Responses to comments below:

Re: Initial Submission Review – Urban Cottages Jewell – Zoning Map Amendment, Site Plan w/Adjustment and Final Plat

Application Number: **DA-2309-00**

URBAN COTTAGES - JEWELL
SITE PLAN
E JEWELL AVE
AURORA, CO

ZONING MAP: PROPOSED R-2 ZONE DISTRICT

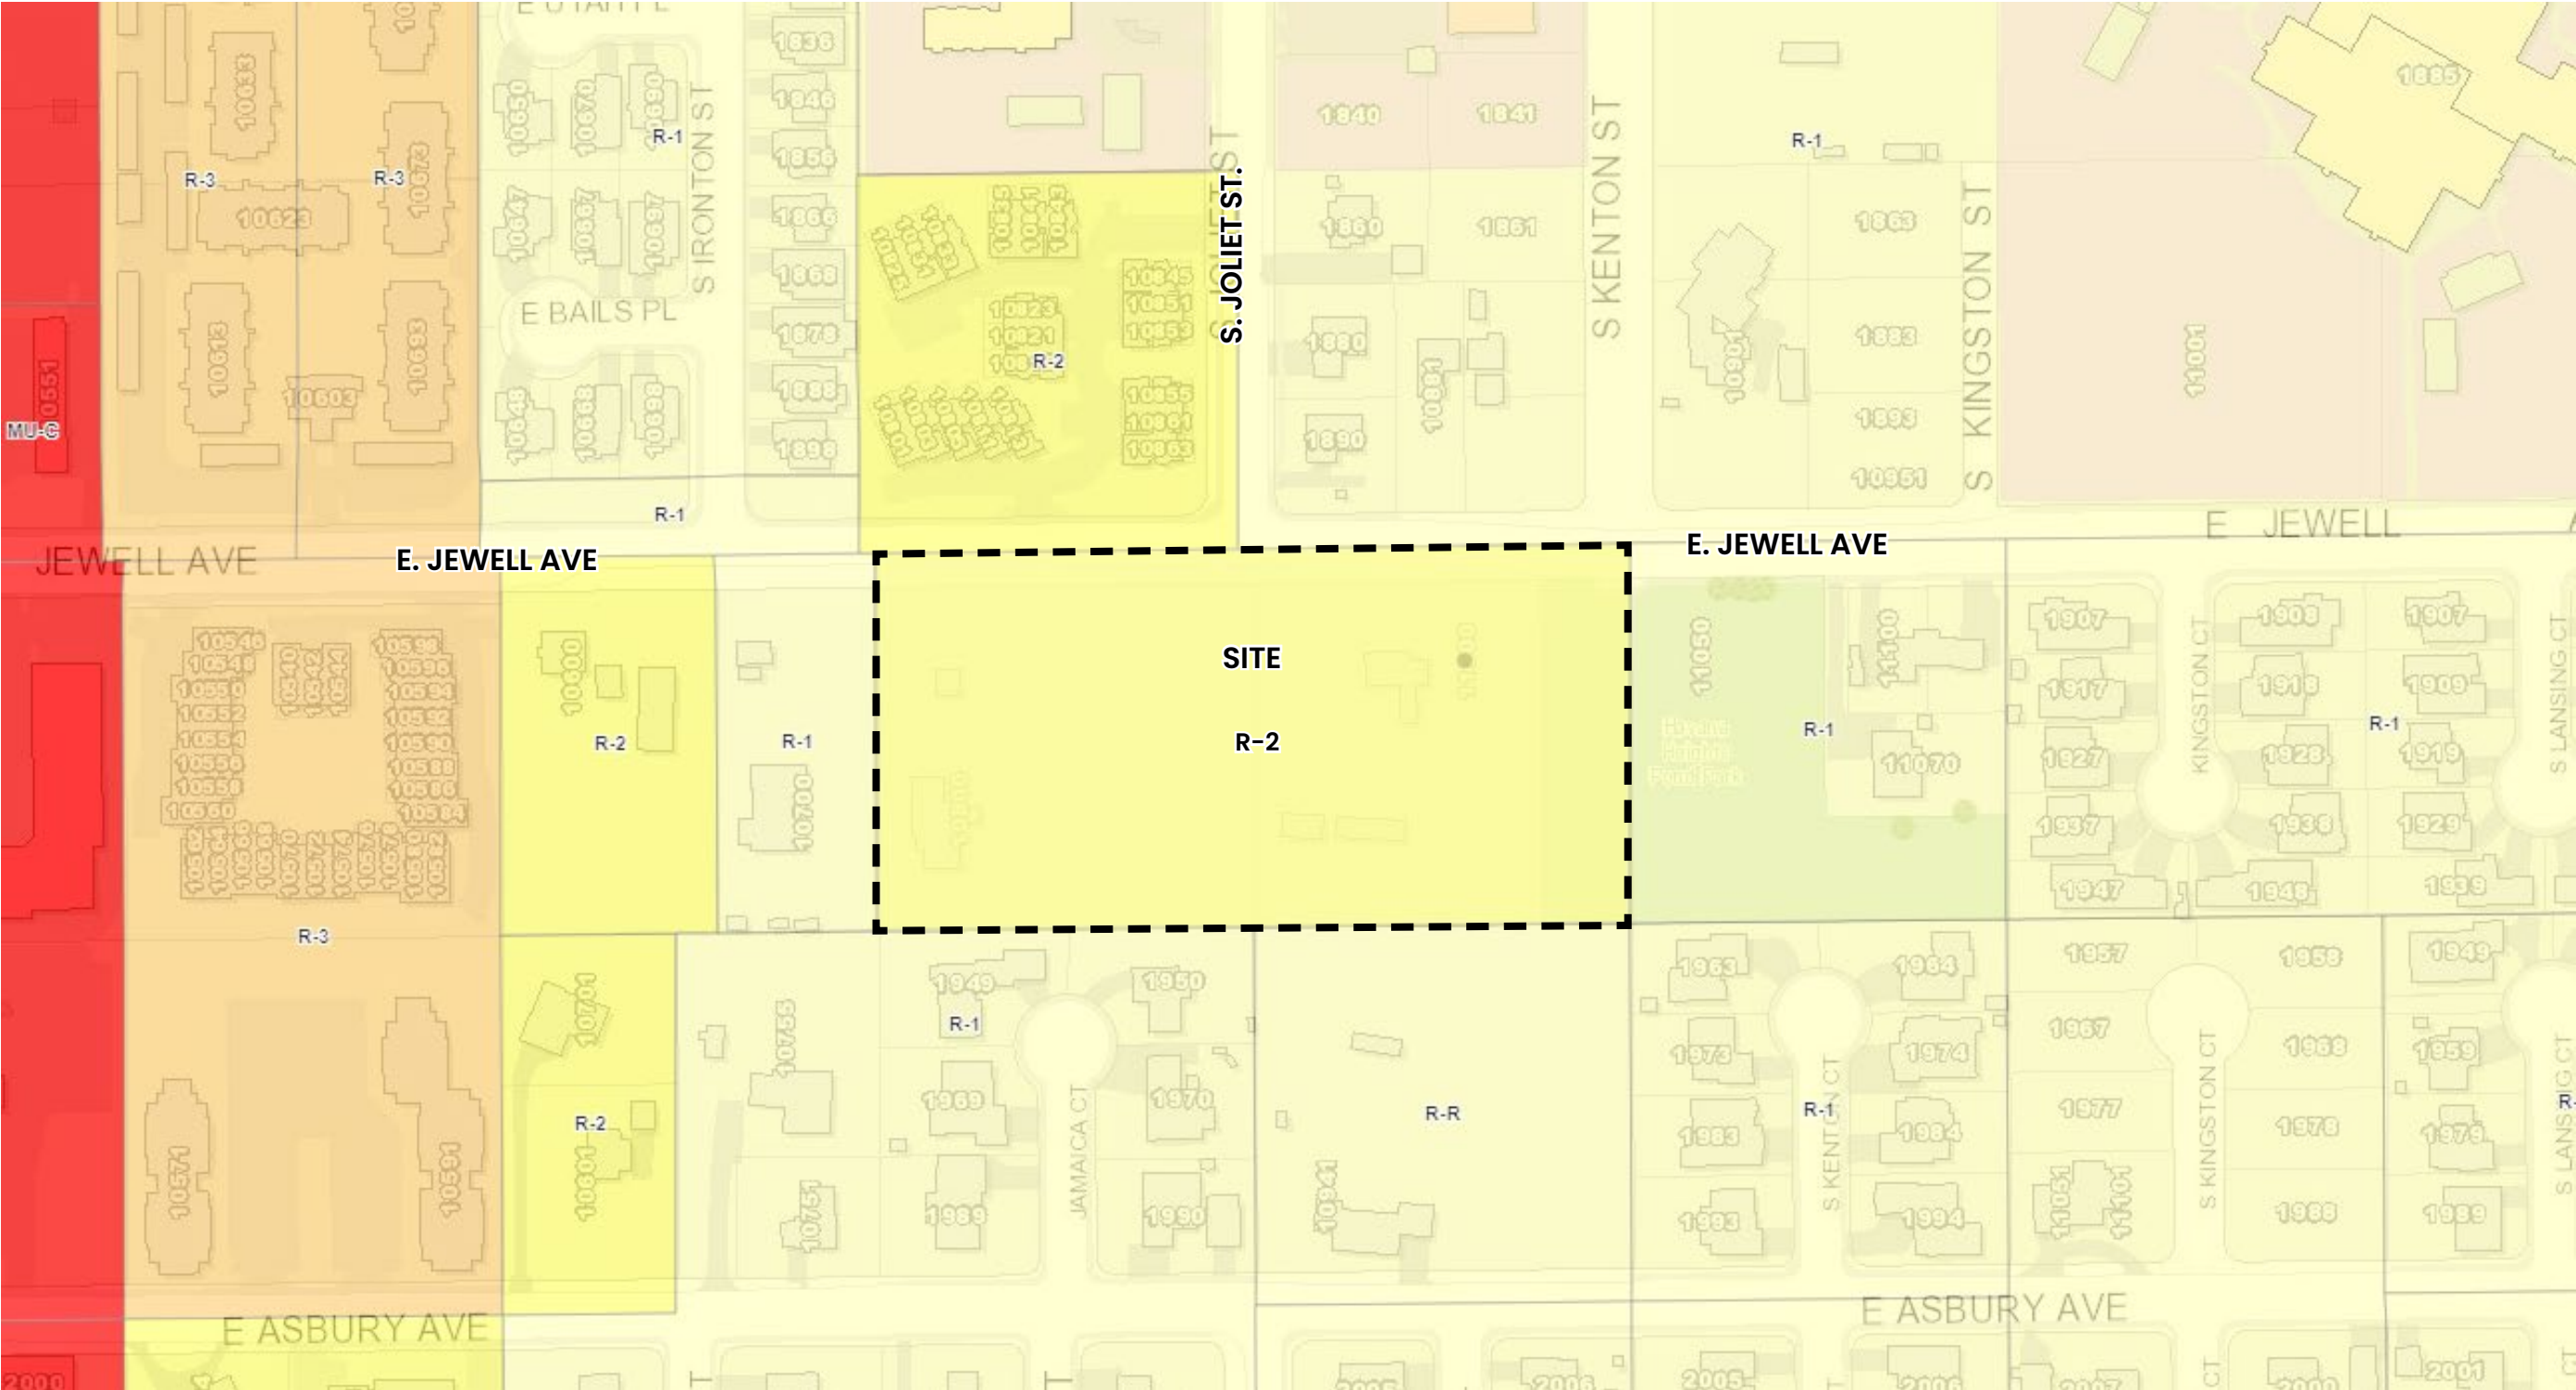
Attach the Zoning Map Amendment exhibit to this PDF to create 1 PDF.

Zoning Map was added to this document - PCS

SHEET NUMBER
C1
1 OF 25

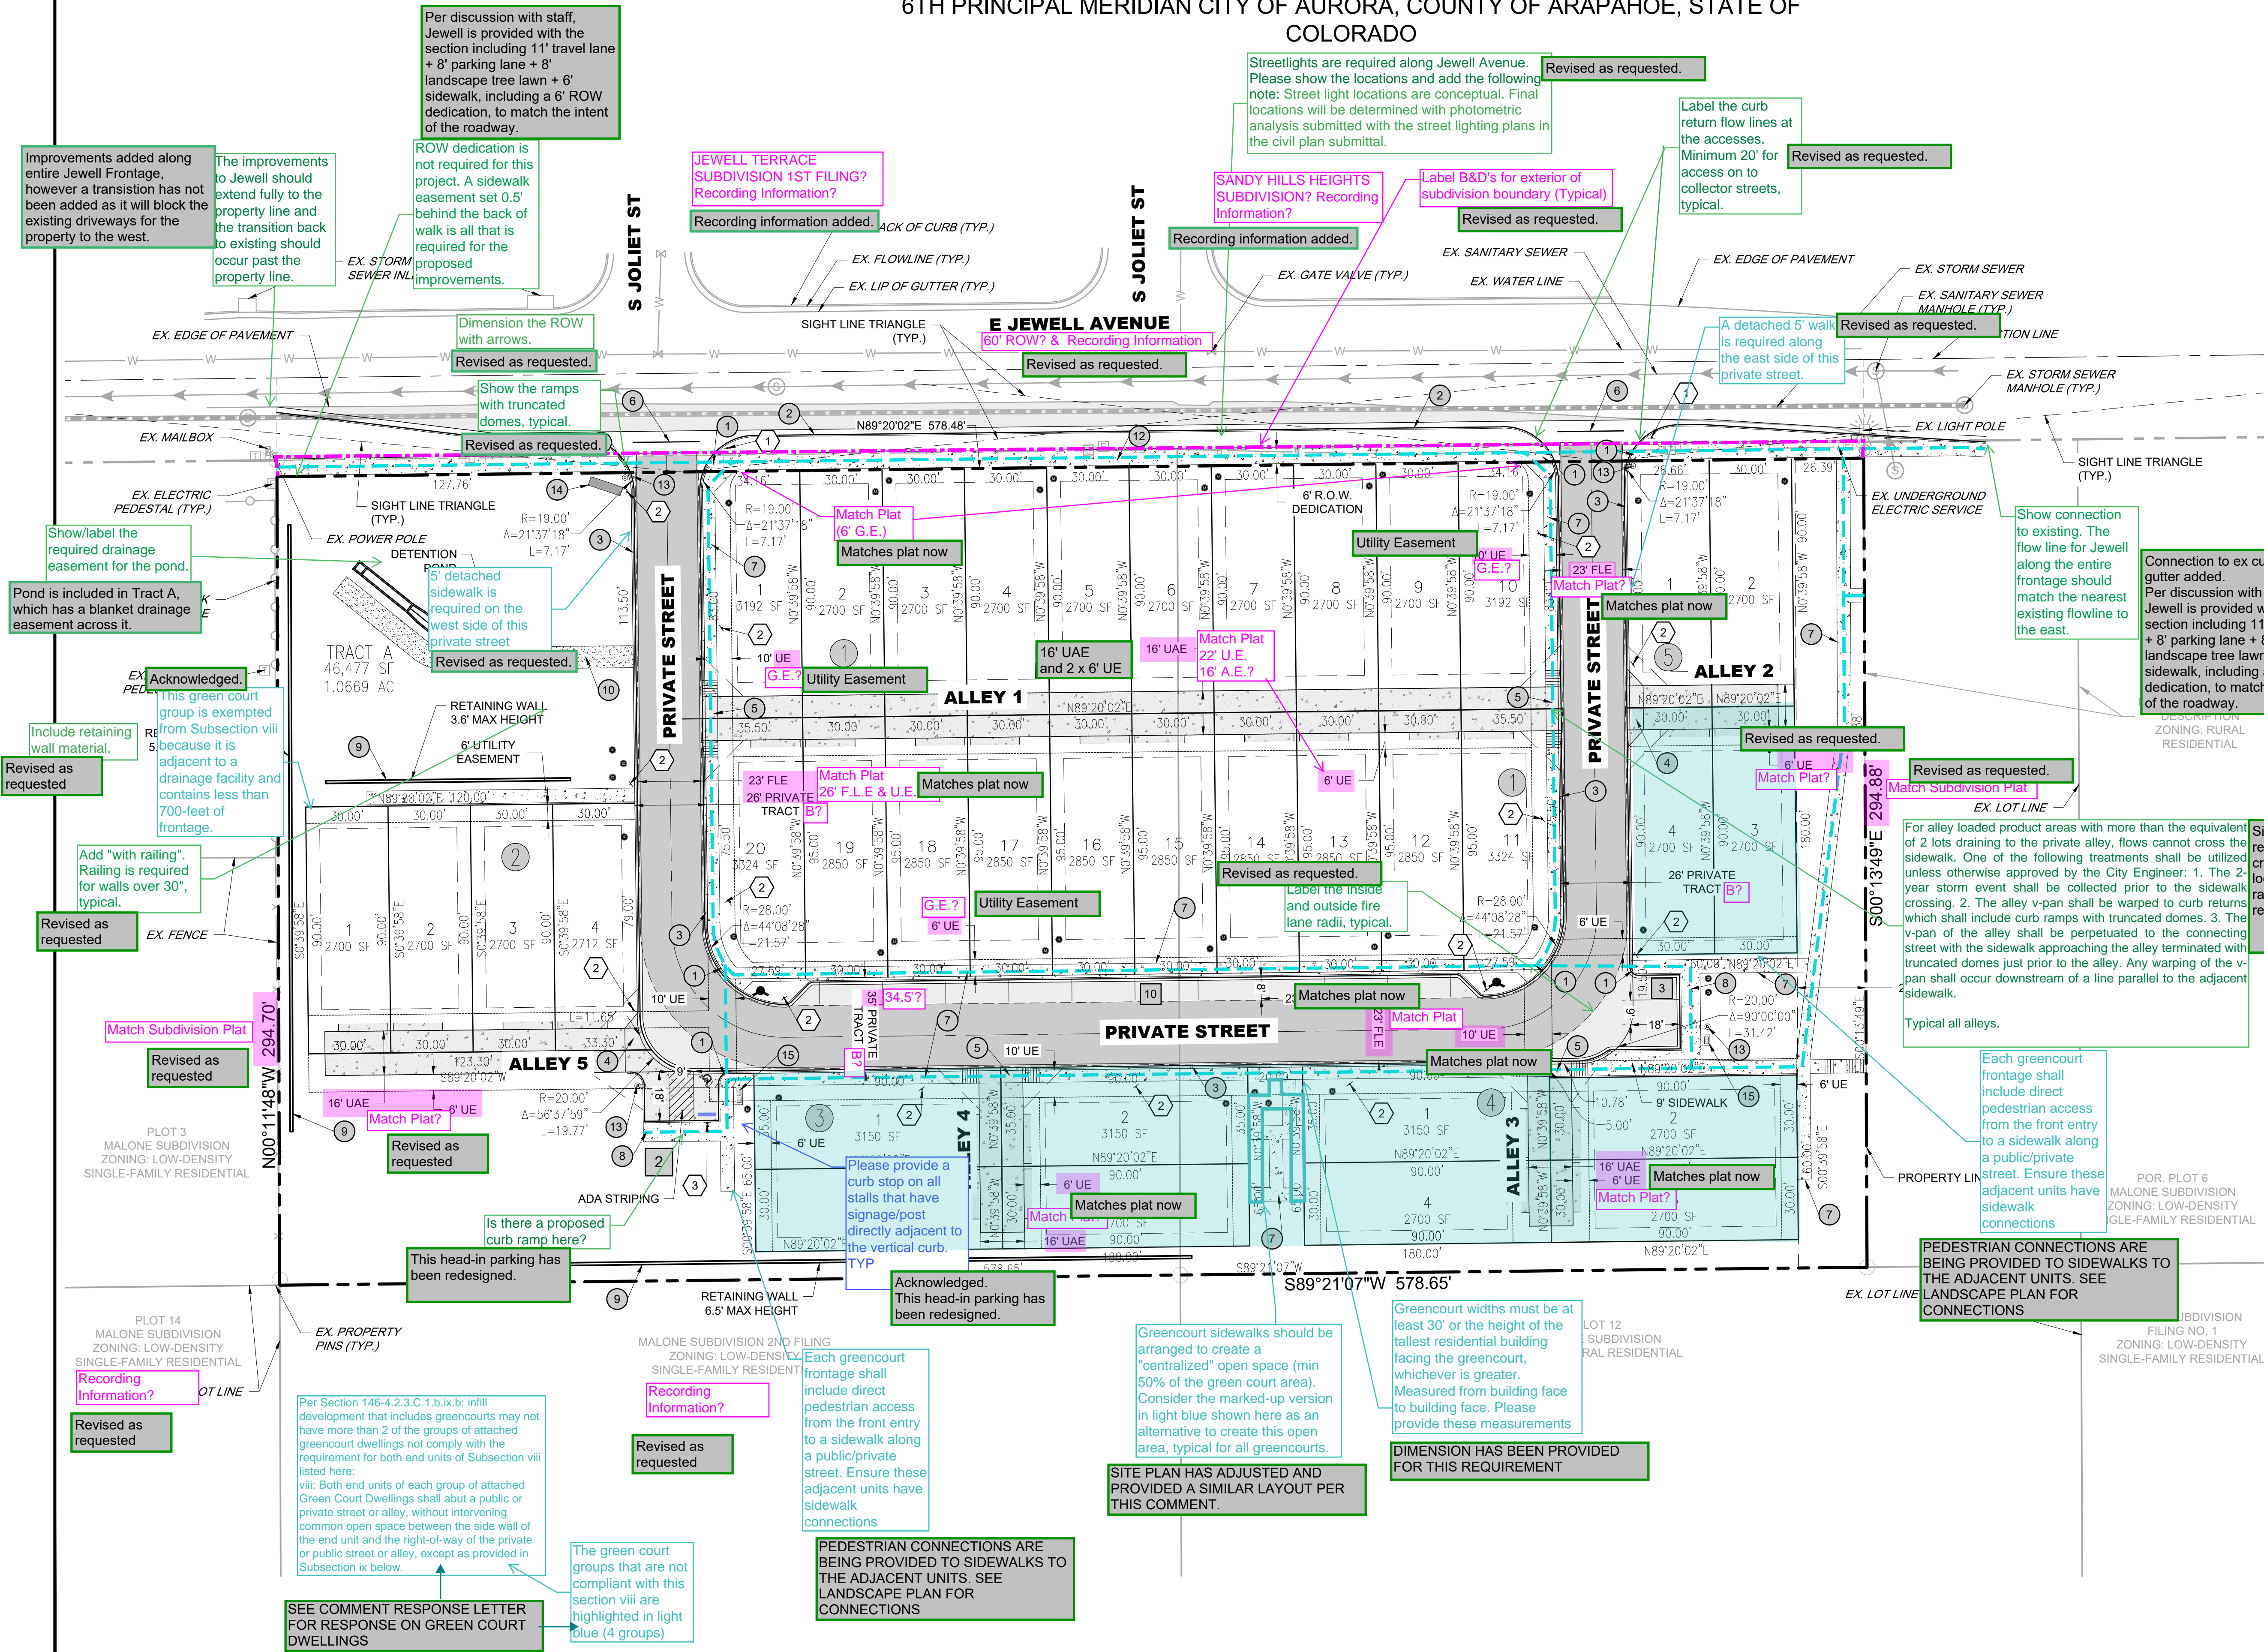
As indicated in the LOI redlines, if there are any mitigation measures taken for this request, please list them here.

Revised as requested

Revised as requested.

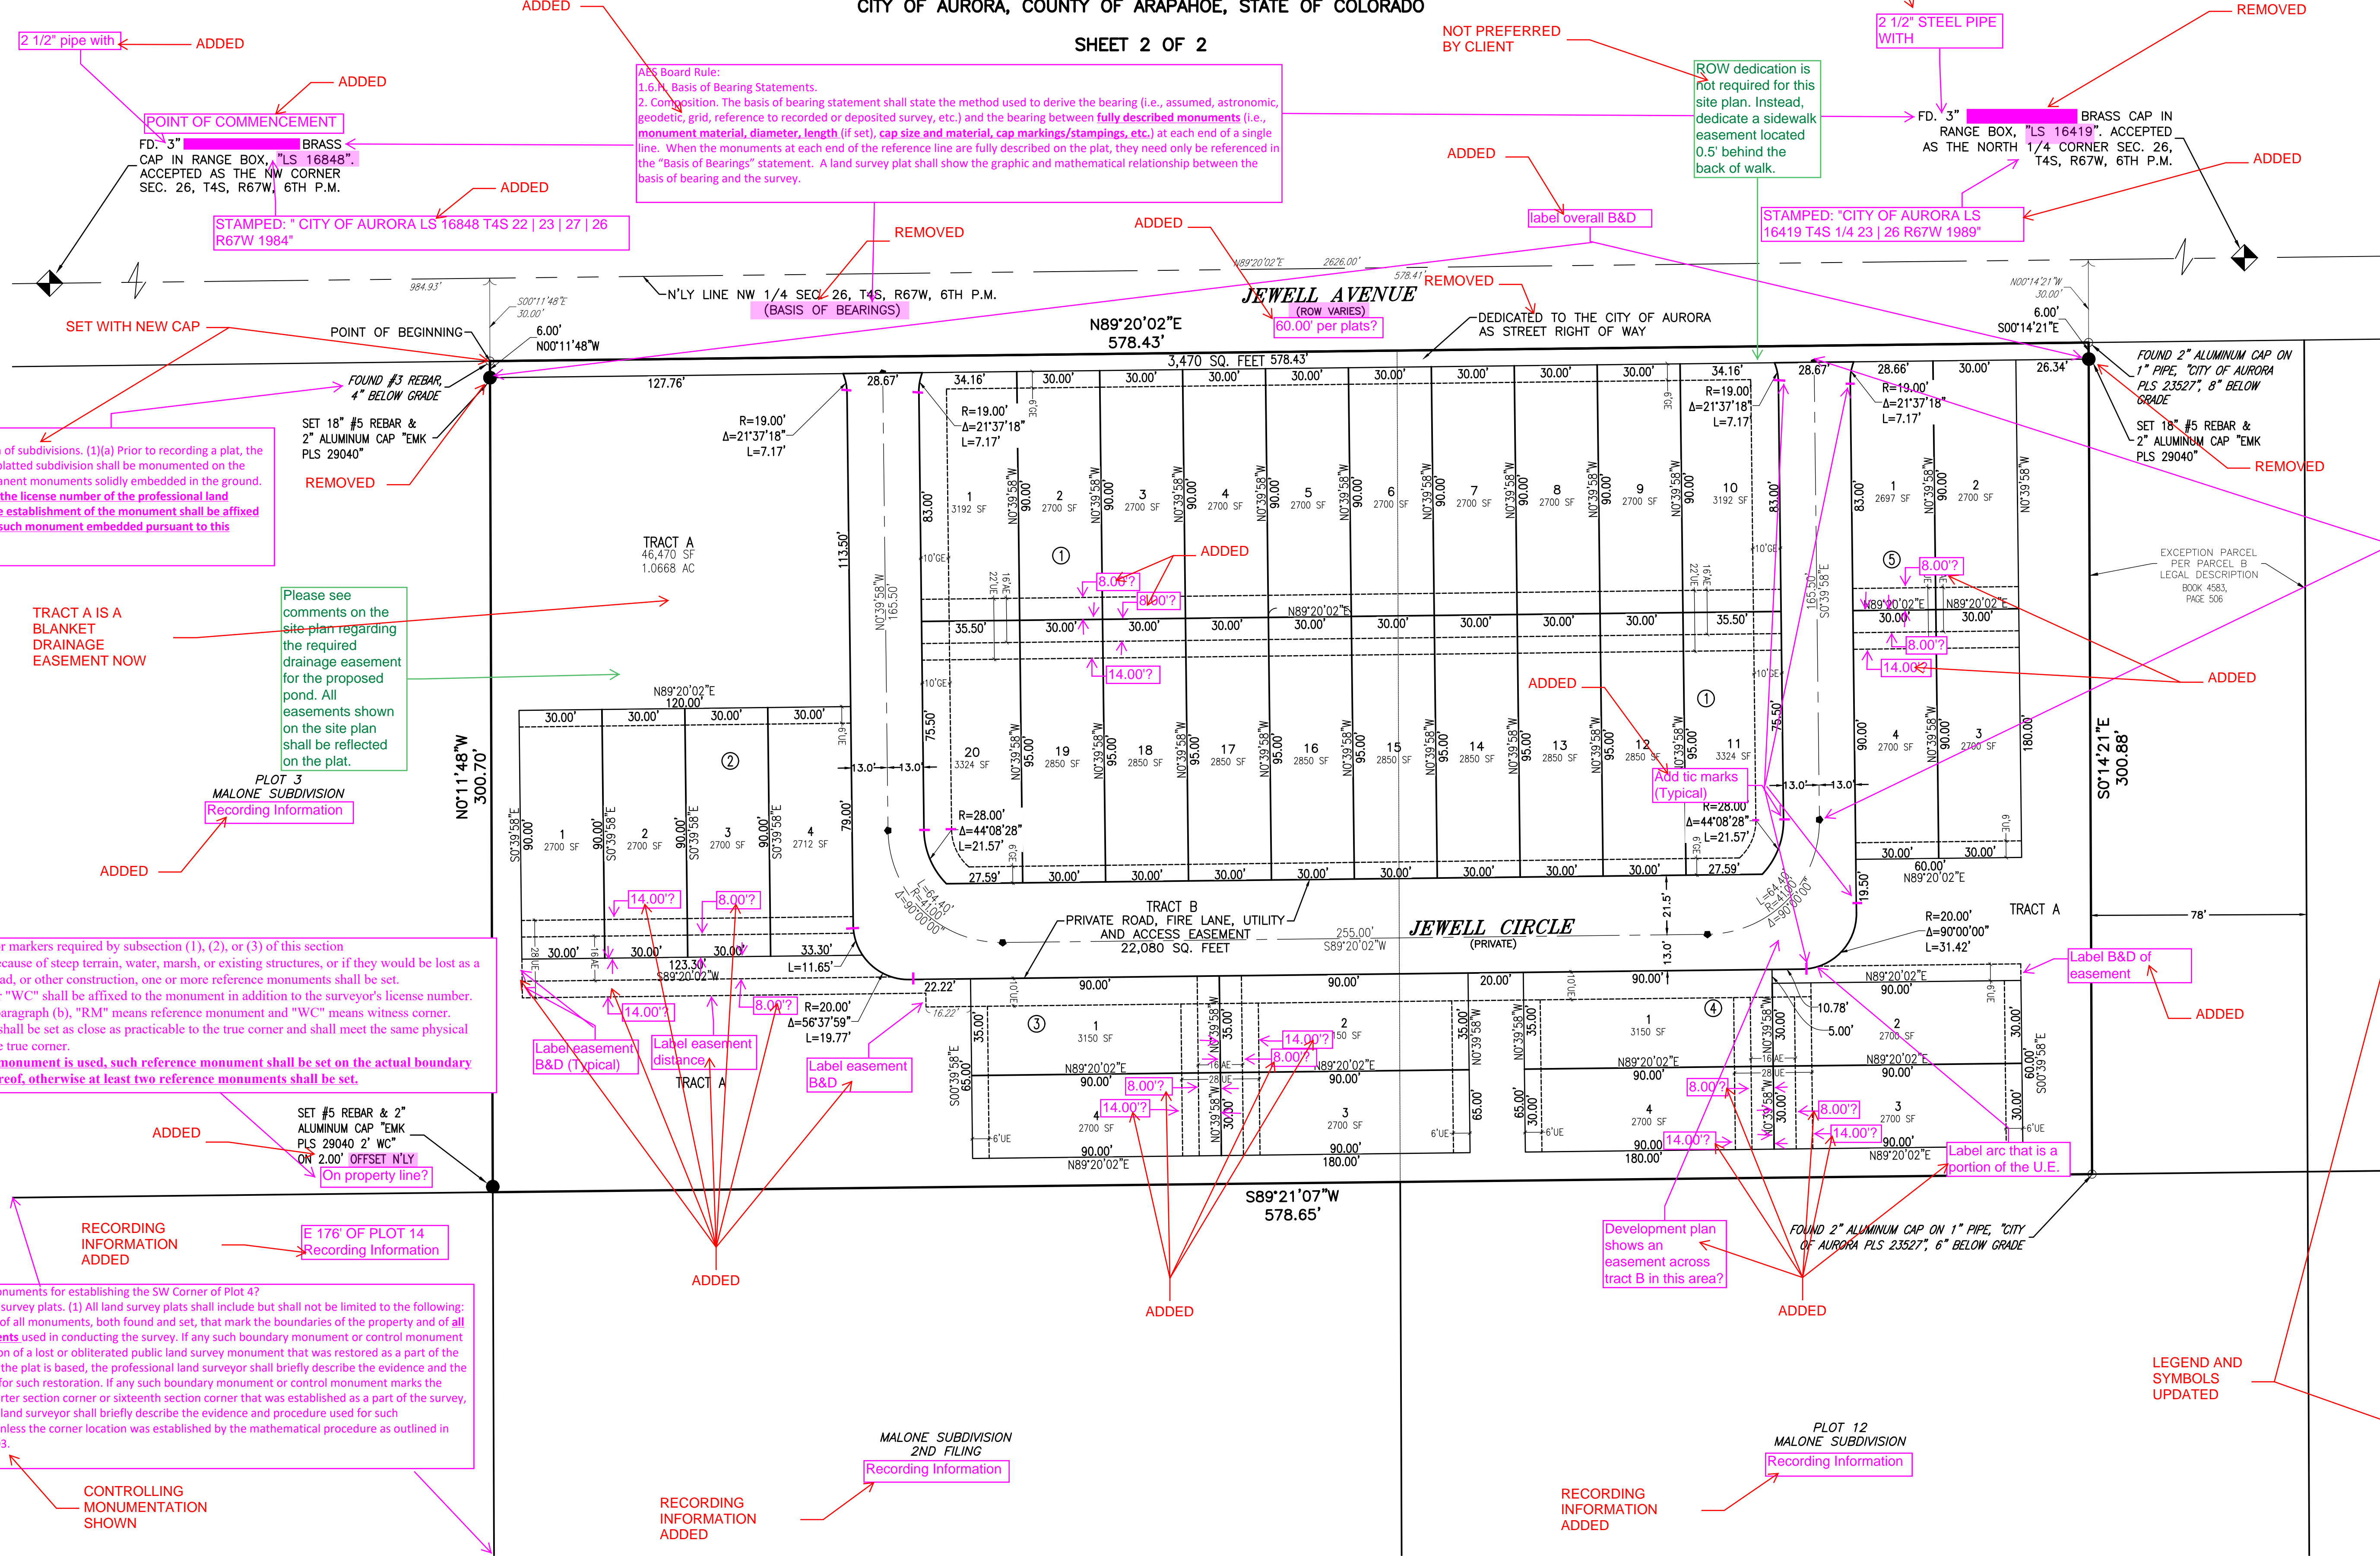
Provide most current AES Board Monument Records

VERIFIED WITH
ENGINEERING

OWNER NAME
REVISED

SIGNATURE BLOCK
REMOVED

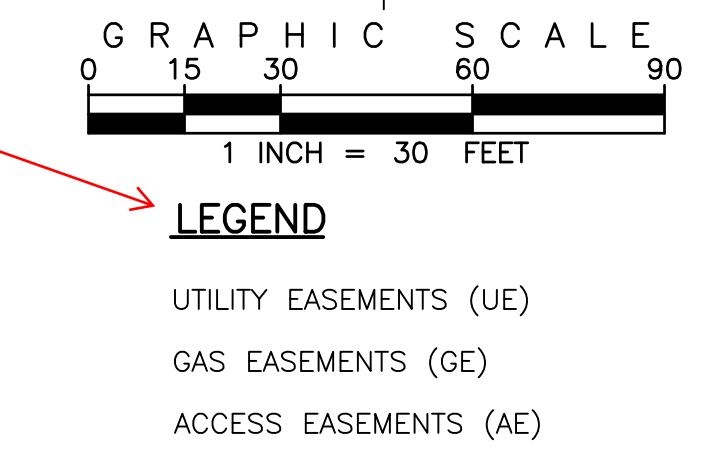
Please see comments on the site plan regarding the required drainage easement for the proposed pond. All easements shown on the site plan shall be reflected on the plat.

TRACT A IS A BLANKET DRAINAGE EASEMENT NOW
